BULLETIN # 178

CP34-43 SPARE PART

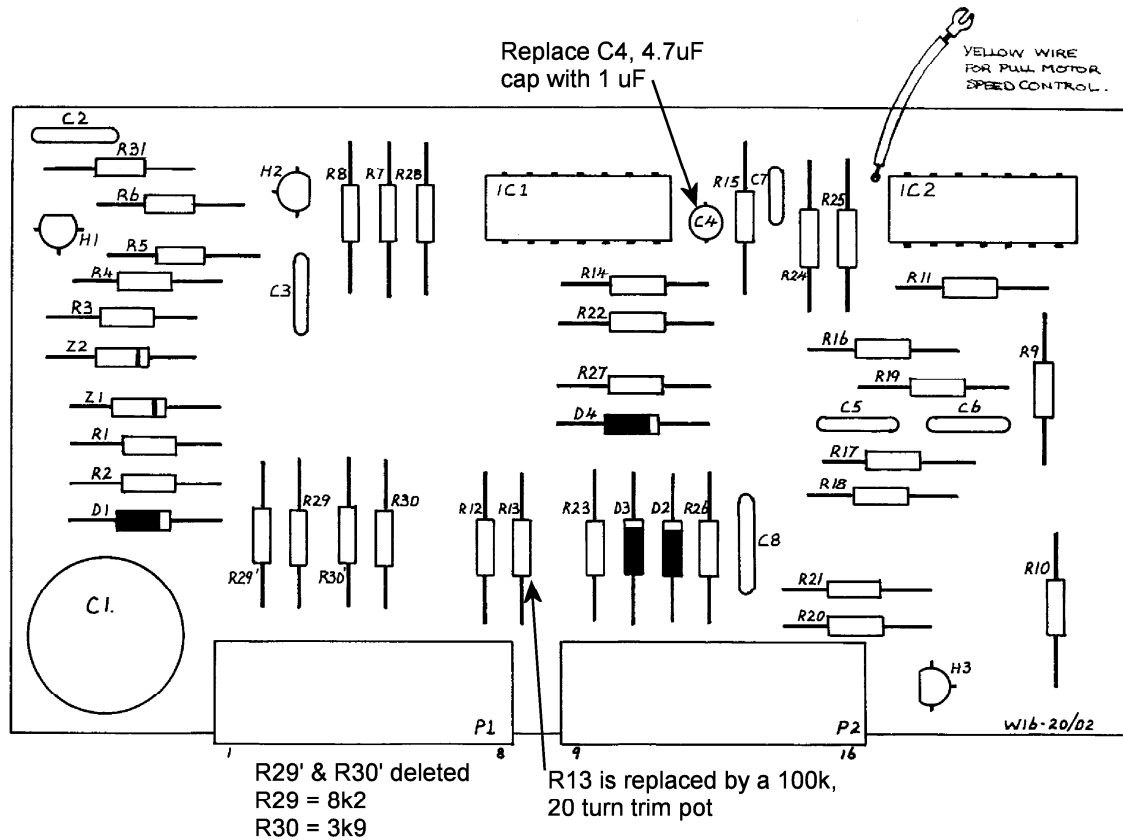
The W34-43 speed control pcb used on the CP34 is no longer available. However the W16-20 speed board can be converted into one using the following diagram as a guide.
